Addendum No. 1, June 4, 2026

RE: Volpe Library Parking Lot Improvements
Tennessee Tech University
Cookeville, Tennessee
TTU Project No. 26-091

From: Civil Engineering and Surveying, LLC
214 East Stevens Street
Cookeville, Tennessee 38501
Telephone (931)528-5266

C1.1
SITE PLAN

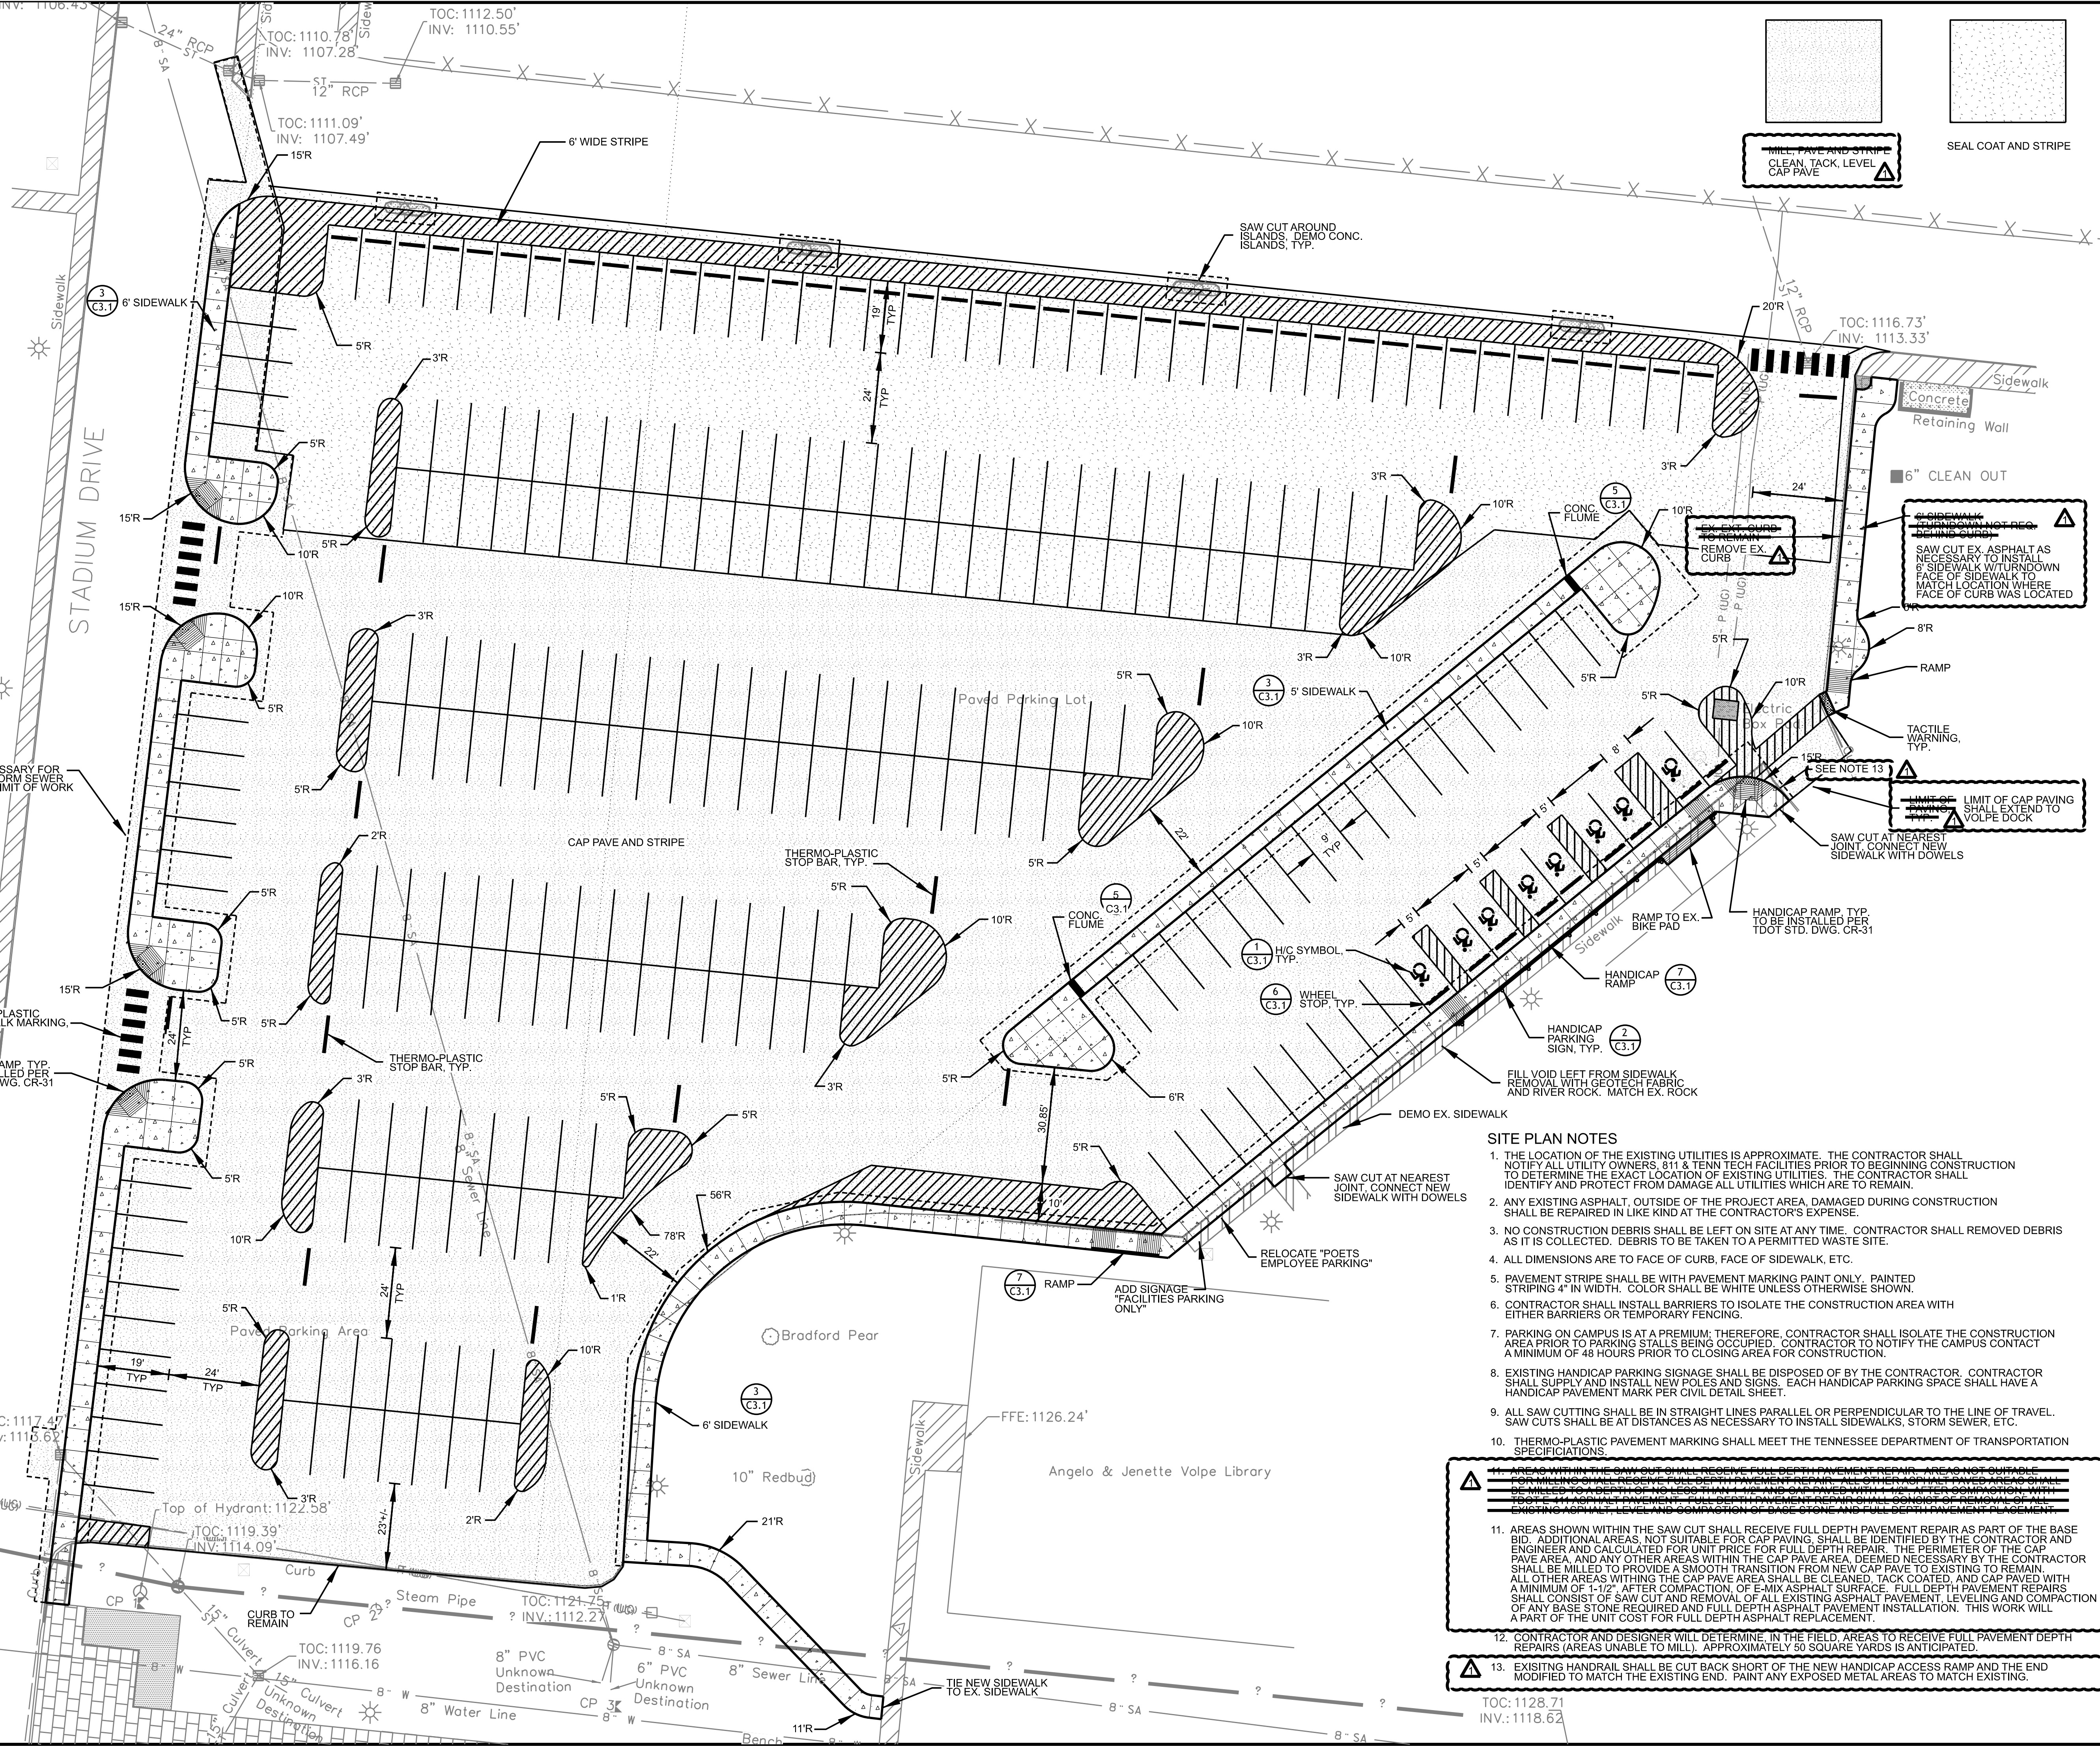
For the area illustrated on Drawing C1.1 as “milling, pave and stripe” milling shall only be performed around the perimeter and other features on the site necessary to provide a smooth transition between the new asphalt pavement cap pave and existing asphalt pavement to remain. The remaining existing asphalt, in this area shall, be cleaned by sweeping, receive tack coat, any leveling necessary to provide a uniform grade and topping of no less than 1-1/2”, after compaction, of E-mix surface asphalt. This work shall be a part of the contractor’s base bid.

Cap paving shall extend into and cap the entire asphalt surface in the Volpe Library dock well.

Existing extruded curb running north south at the northeast corner of the site, noted as to remain on sheet C1.1 Site Plan, shall be removed. The proposed 6-foot sidewalk shall be shifted to the

west so that the face of sidewalk matches to location of the removed face of curb. The existing electrical pull box shall be adjusted to match sidewalk grade.

Added note 13 to sheet C1.1 “EXISTING HANDRAIL SHALL BE CUT BACK SHORT OF THE NEW HANDICAP ACCESS RAMP AND THE END MODIFIED TO MATCH THE EXISTING END. PAINT ANY EXPOSED METAL AREAS TO MATCH.”

13. EXISTING HANDRAIL SHALL BE CUT BACK SHORT OF THE NEW HANDICAP ACCESS RAMP AND THE END MODIFIED TO MATCH THE EXISTING END. PAINT ANY EXPOSED METAL AREAS TO MATCH EXISTING.

SHEET NO. **C2.1**
 TITLE: **GRADING & DRAINAGE**
 TTU PROJECT NUMBER: **26-091**
 DATE: **5-27-26**

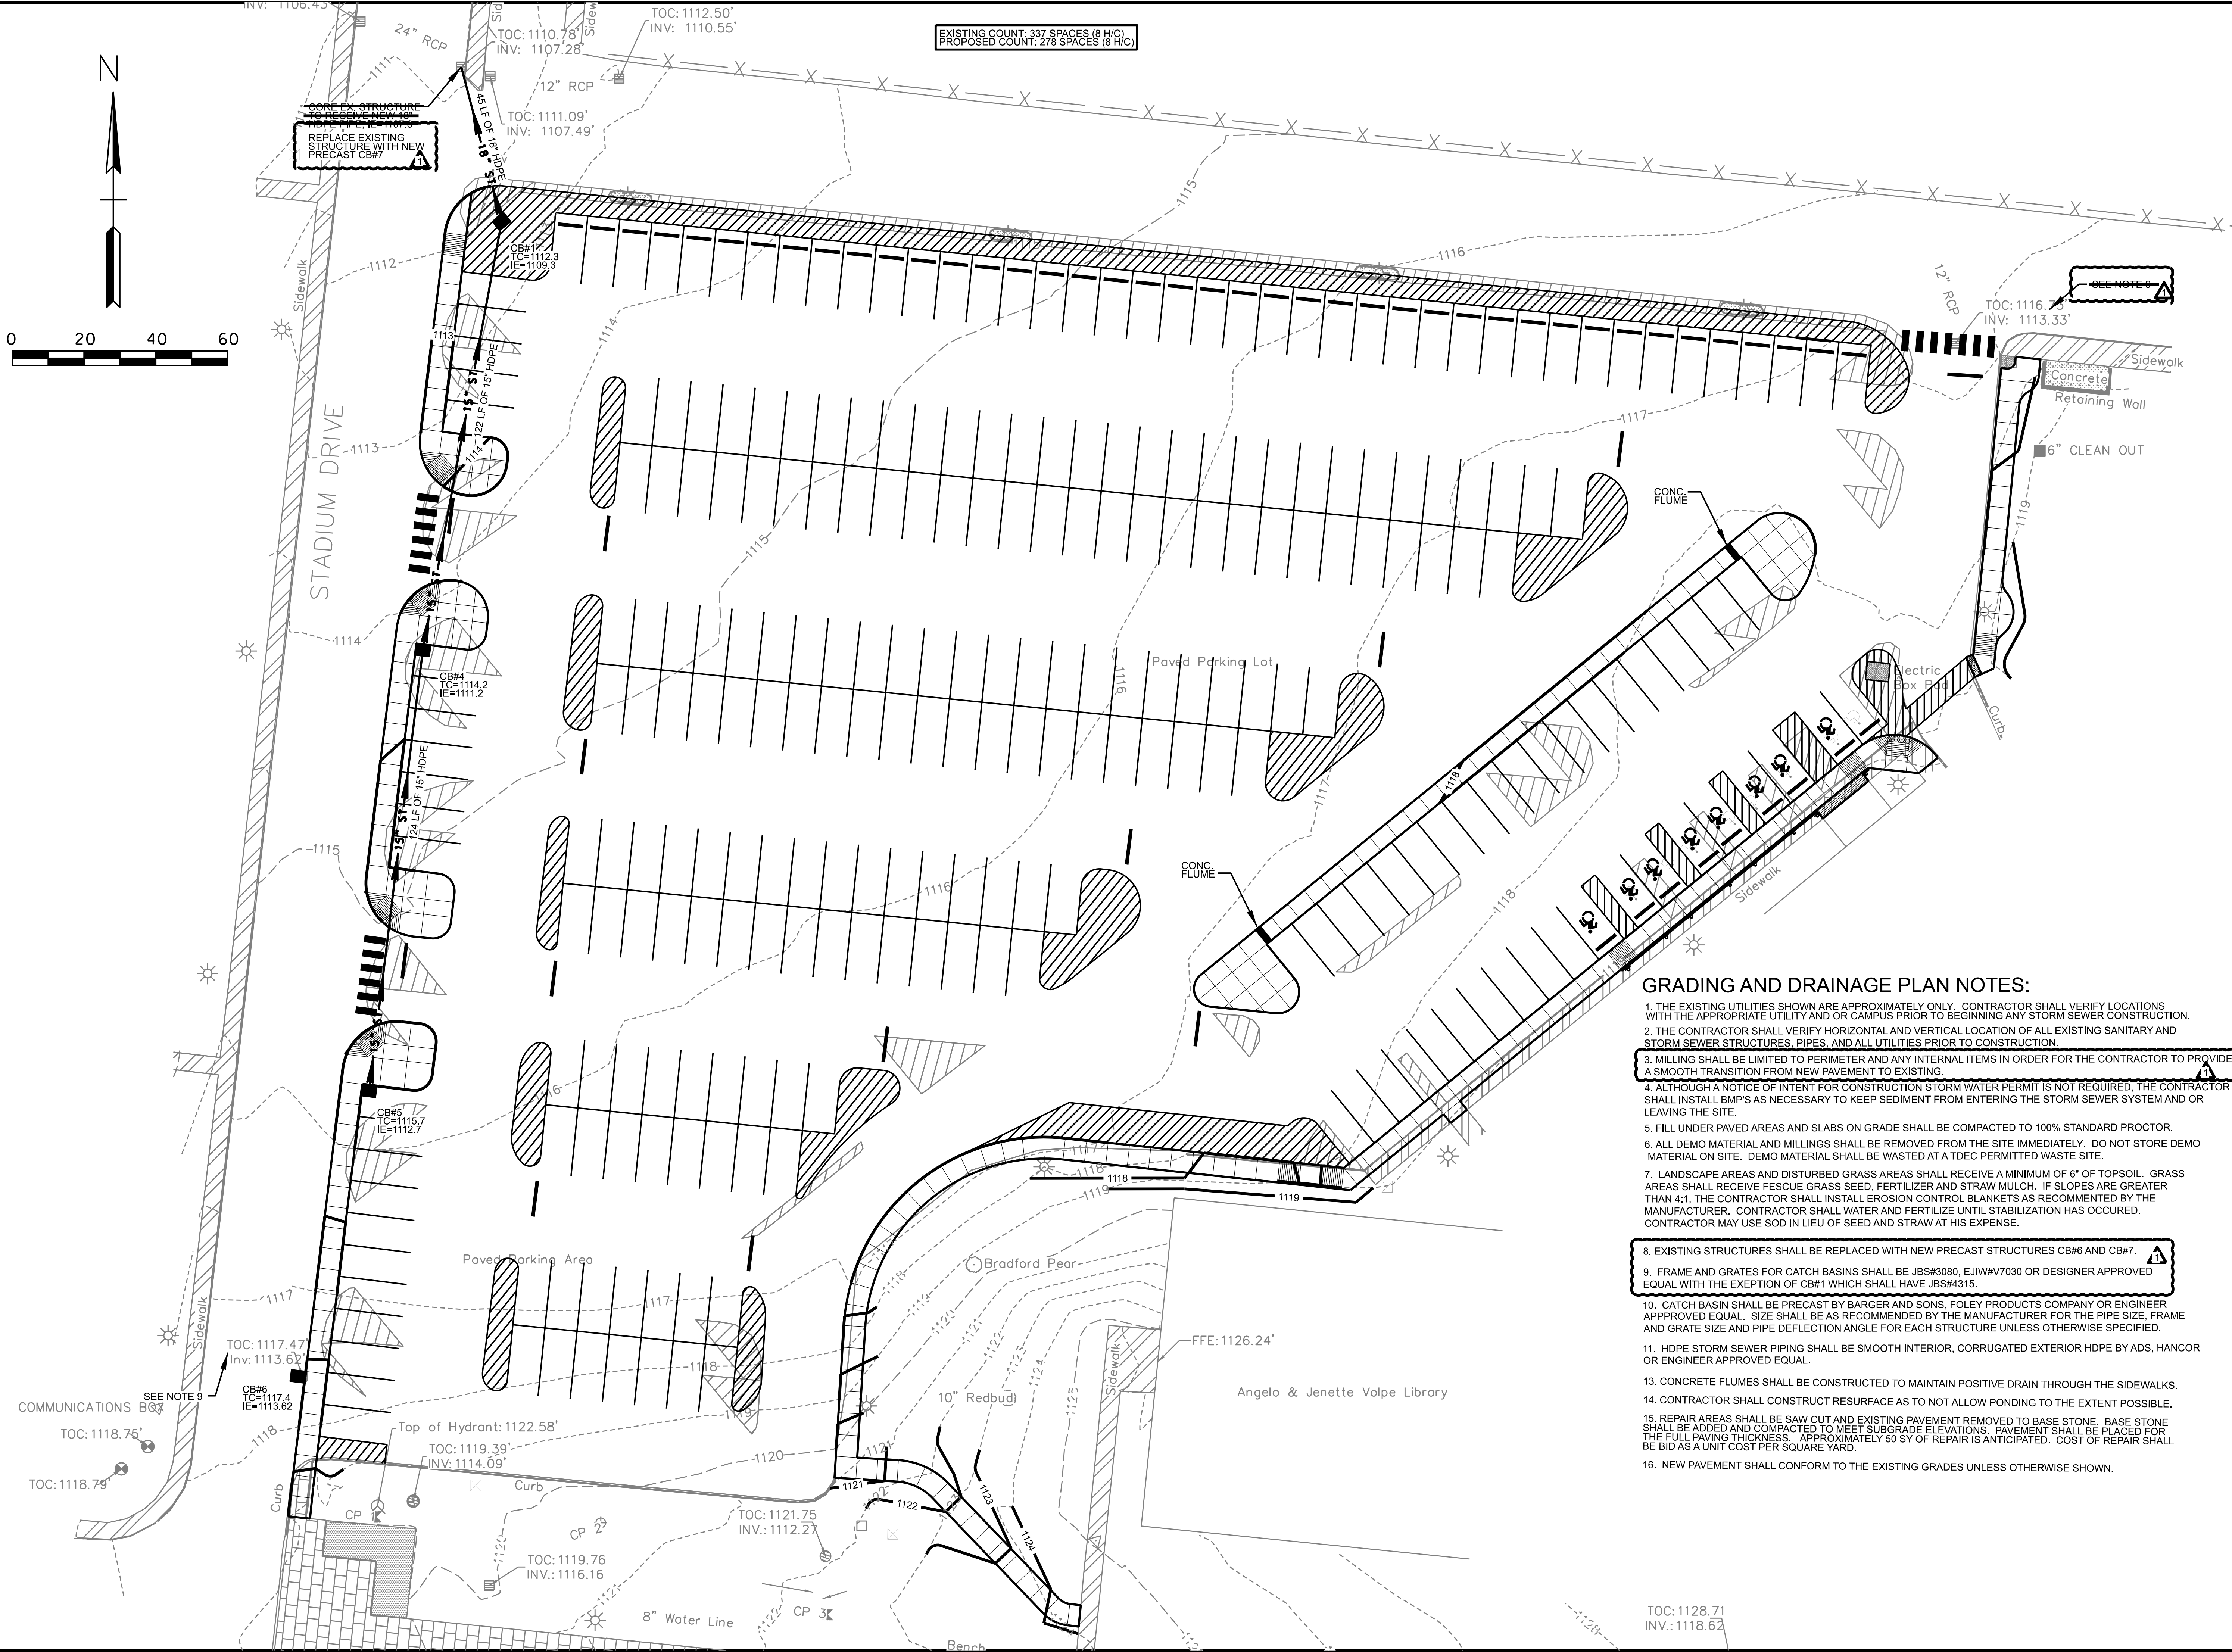
Existing tie-in catch basin, downstream of new catch basin #1 shall be replaced with a new precast structure and grate per design drawings. This basin will be CB#7.

Note 8 sheet C2.1 shall be revised to “EXISTING STRUCTURES SHALL BE REPLACED WITH CB#6 AND CB#7.

REPLACE EXISTING STRUCTURE WITH NEW PRECAST CB#7

8. EXISTING STRUCTURES SHALL BE REPLACED WITH NEW PRECAST STRUCTURES CB#6 AND CB#7.
9. FRAME AND GRATES FOR CATCH BASINS SHALL BE JBS#3080, EJIW#V7030 OR DESIGNER APPROVED EQUAL WITH THE EXCEPTION OF CB#1 WHICH SHALL HAVE JBS#4315.
